PASSAIC RIVER BASIN

# CRYSTAL LAKE DAM

PHASE I INSPECTION REPORT

NATIONAL DAM SAFETY PROGRAM

FIGURE 3

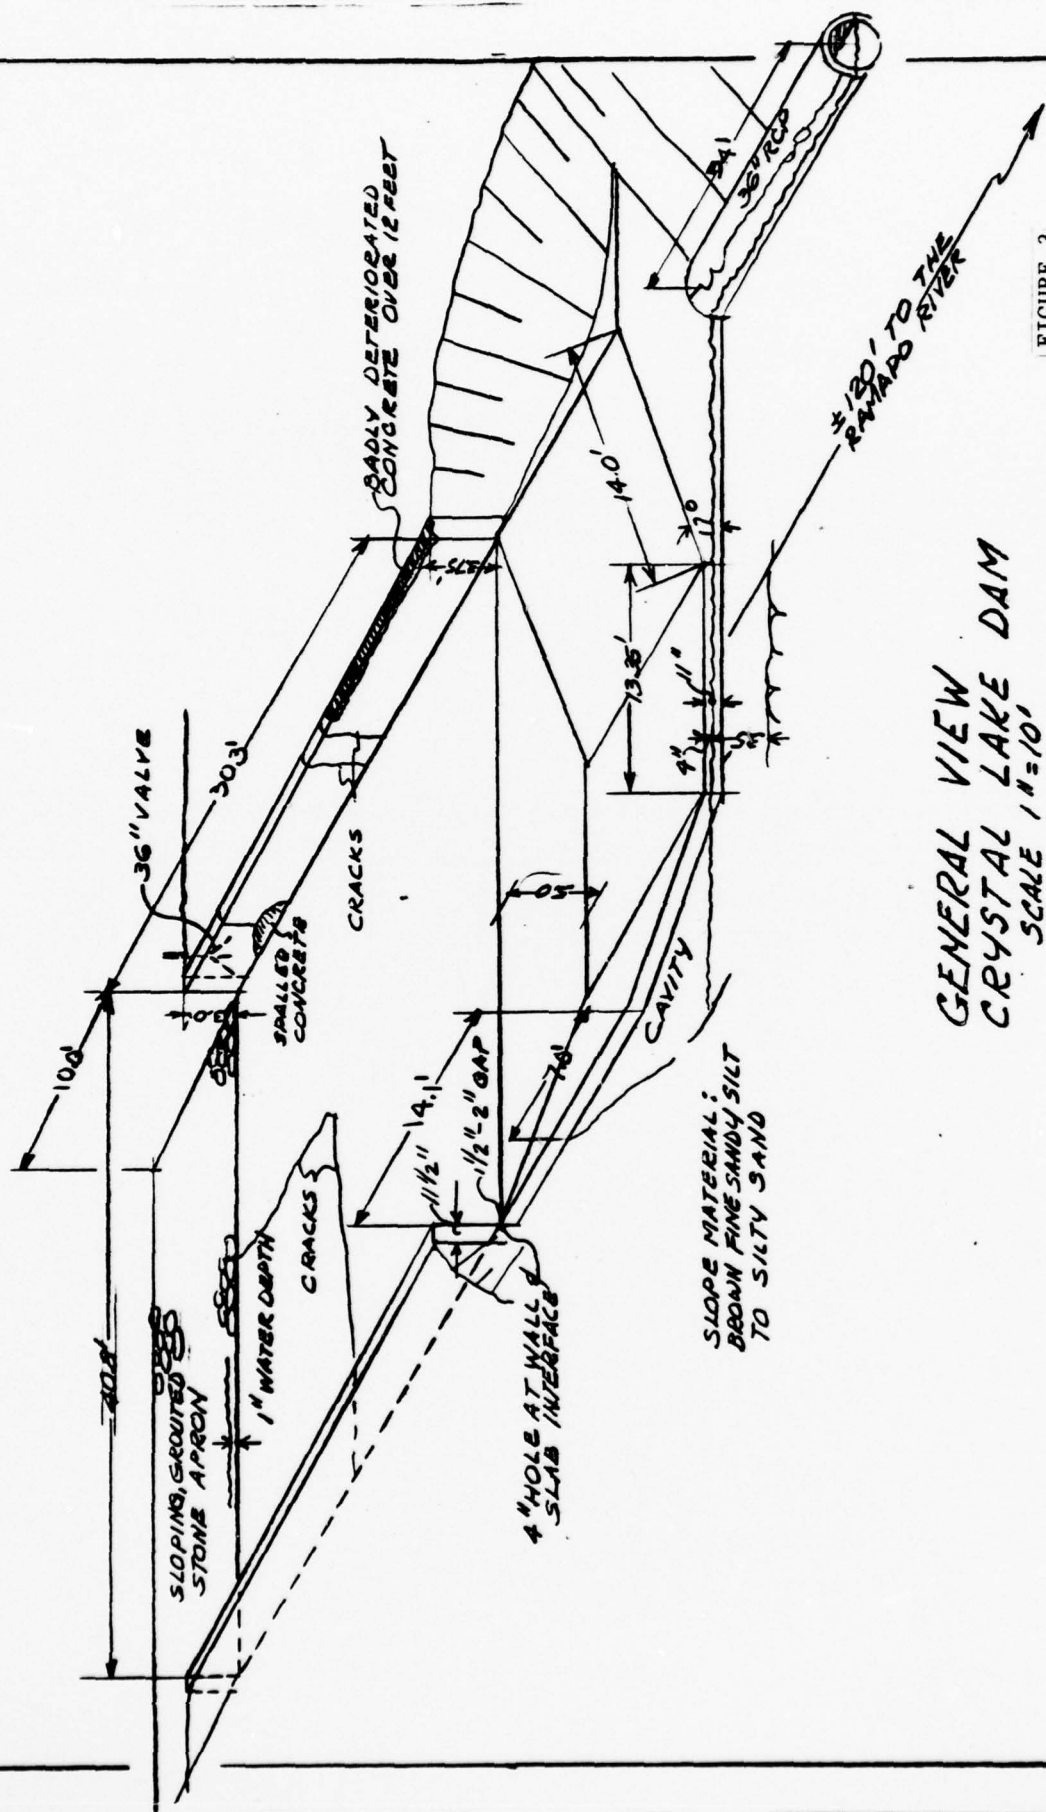
c. Validity: Cannot be judged considering unavailability of record drawings. A sketch of the concrete structure based on field measurements is shown in Figure 3. Appendix C shows photographic details of several portions of the structure described and evaluated within this report.

UPSTREAM LEFT ABUTMENT  
HEAD WALL DAMAGE

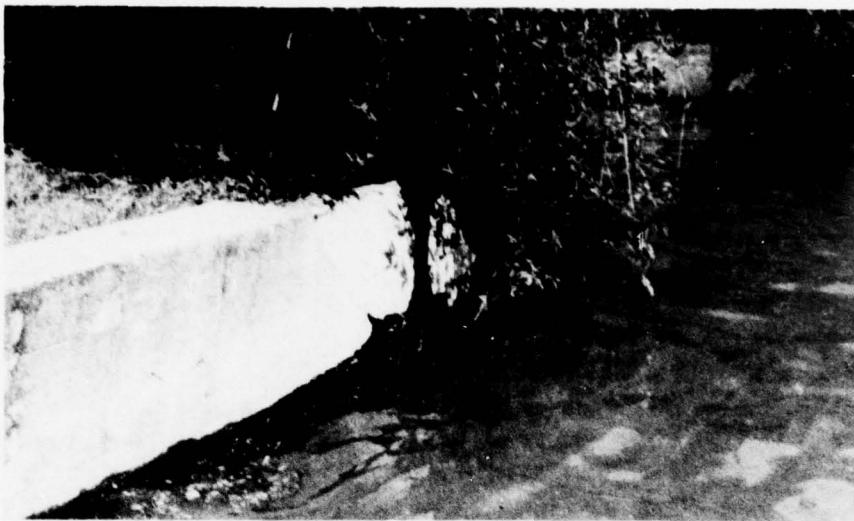
VISUAL EXAMINATION OF	OBSERVATIONS	REMARKS OR RECOMMENDATIONS
STRUCTURAL CRACKING	<p>The left wing wall, at the intake side, has a 45° crack running from top of wall to top of 36-inch outlet pipe. The top of this concrete wall is badly deteriorated and the wall is tilted towards lake. The left wall has two vertical cracks, 3 feet apart, 12 feet from downstream edge of wall.</p>	
VERTICAL AND HORIZONTAL ALIGNMENT	Fairly good.	
MONOLITH JOINTS	None visible.	
CONSTRUCTION JOINTS	<p>At the right downstream corner of the wall and the slab a 4-inch gap was found. A 2-inch gap exists between the slab and downstream drop apron; a 4-inch void was found below the right downstream wall and slab.</p>

(2) The cracked and tilted left hardwall at the 36-inch pipe drain should be repaired before its failure obstructs or damages the outlet gate.

UPSTREAM LEFT ABUTMENT  
NOTICE TILTED HEAD WALL

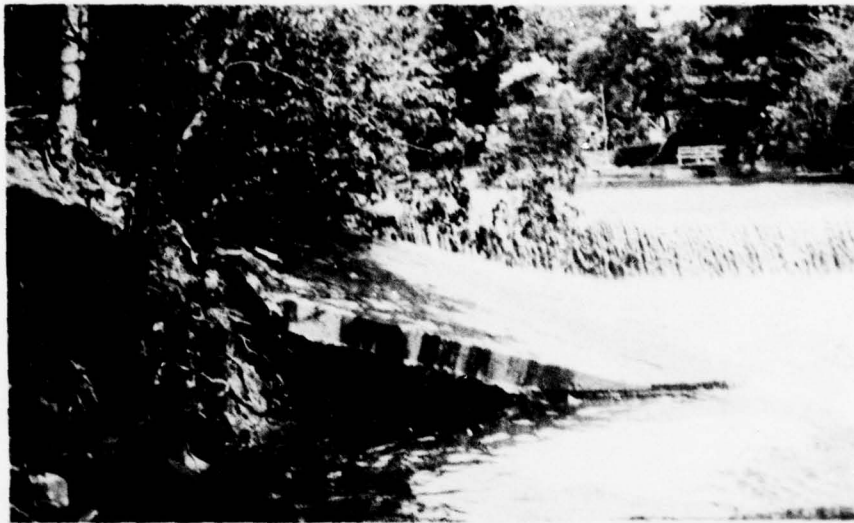
The dam/spillway is in poor condition, as defined in Appendix G. It can pass the 50-year flood, but is inadequate to pass the 100-year flood. The foundation of the downstream apron has been extensively undermined, which increases the possibility of structural failure of the apron. One spillway channel wall has several cracks, and the upstream headwall at the outlet drain is badly cracked and tilted.
